FINAL
Environmental Impact Report
Oak Hill Apartments Project
Unincorporated Marin County, California
State Clearinghouse Number 2022030718

SECTION 2: RESPONSES TO WRITTEN COMMENTS

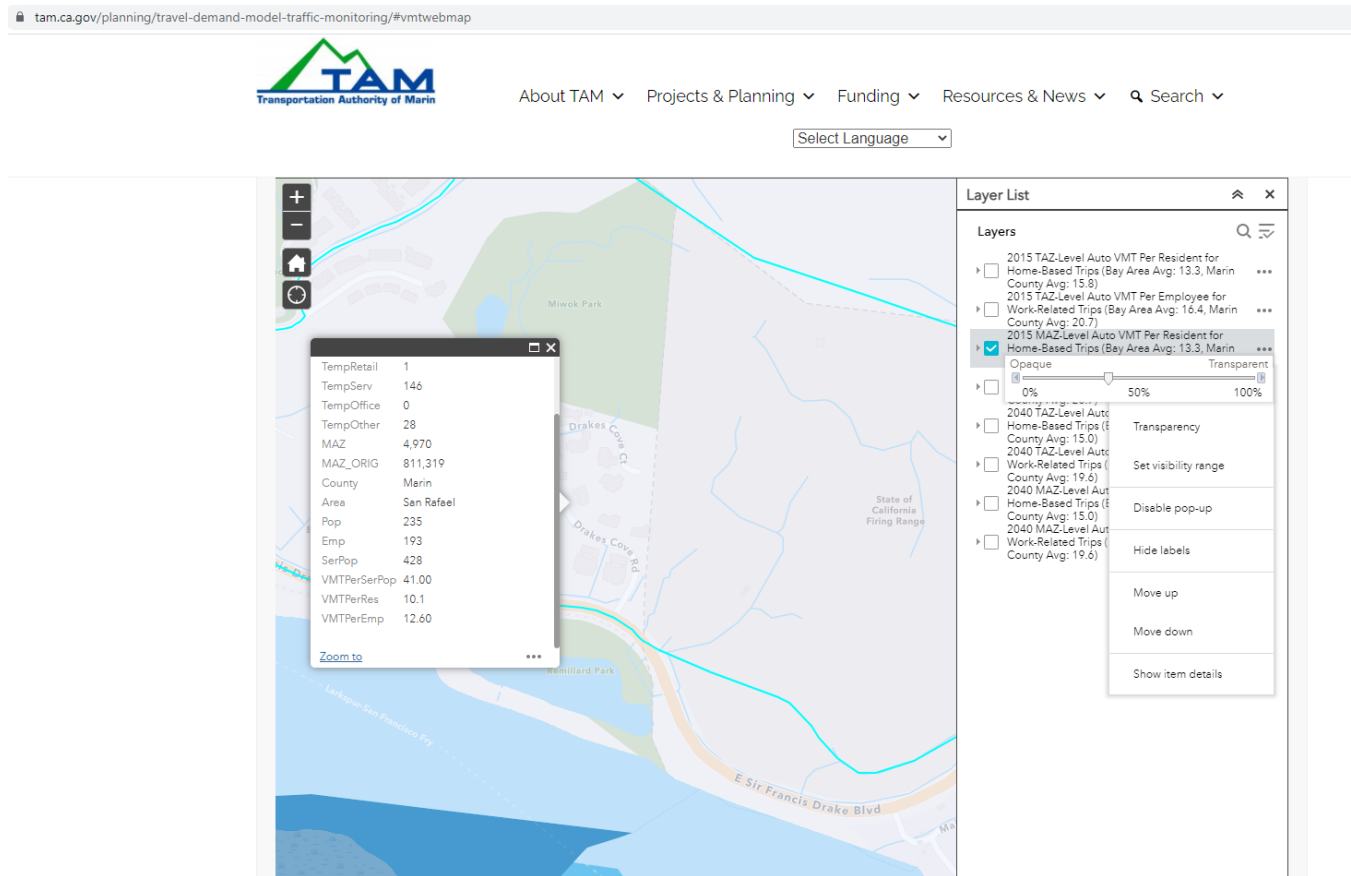
III. Draft EIR Section 3.12 (Appendix I), and Alternatives 2 Through 5, Transportation and Ingress/Egress

Section 3.12 and Appendix I, along with Alternatives 2-5, address traffic, ingress, and egress issues raised by the project. To be honest, this section and the supporting materials were very difficult to decipher, since they rely on multiple statistical models interacting with one another. I am a graduate of Berkeley Law and a member of the California Bar, and had a hard time following the analysis that concludes that there are no significant transportation impacts from adding 250 units and nearly 400 cars to a thoroughfare that is already clogged at peak hours. Apparently, what most people would consider to be common sense issues to evaluate, such as traffic bottlenecks and significant reductions in Level of Service (LOS) at affected intersections, are not actually relevant under new laws and regulations pertaining to CEQA. LOS reductions and traffic delays are excluded from consideration as significant impacts.

MAZ 800,244 2015 Actual

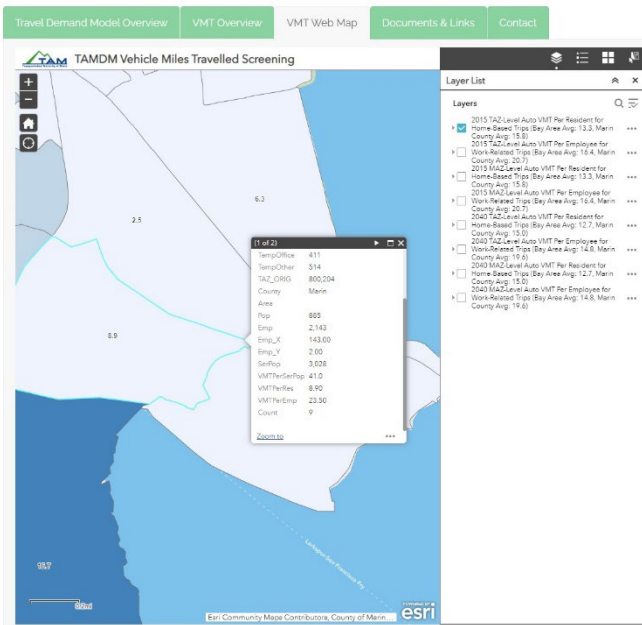
Ms. Rachel Krusenoski of FirstCarbon provided a working link to TAM's MAZ data, which has the project in MAZ 800,244, an MAZ which covers a larger area than the one depicted above. Below are the VMT calculations for MAZ 800,244, based on 2015 actual numbers (population 885, VMT 8.9) and a 2040 projection (population 1235, VMT 10.5). The project will significantly affect those population numbers, particularly in light of further expected development on the Ross Valley Sanitation District Parcel at the corner of Larkspur Landing Circle and East Sir Francis Drake Blvd.

MAZ 800,244 2040 Projected

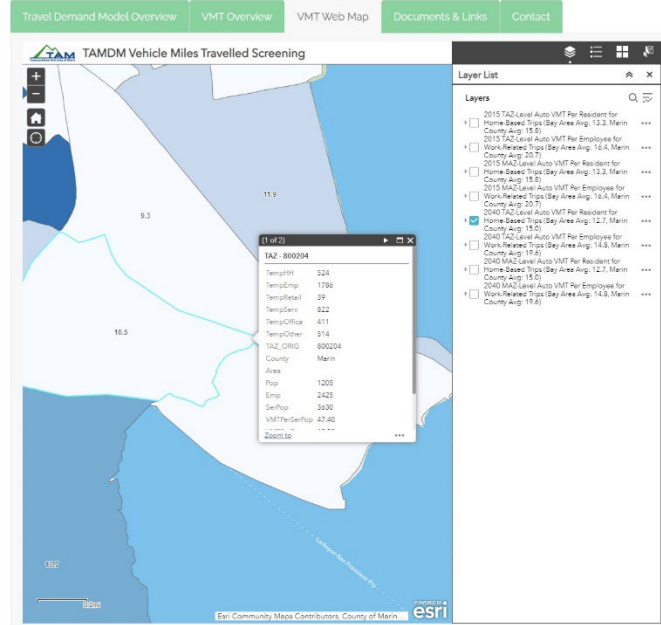
Based on the fact that all available data, for whichever MAZ is applicable, demonstrates that the project will be a significant portion of the population of the MAZ, new analysis should be conducted taking into account the projected VMT for project residents. If DGS and the developers feel that VMT would remain below the significance threshold of 13.4, they should at least provide their detailed reasoning for coming to that conclusion. Such new study and analysis will require DGS and the developer to revise and reissue the Draft EIR.
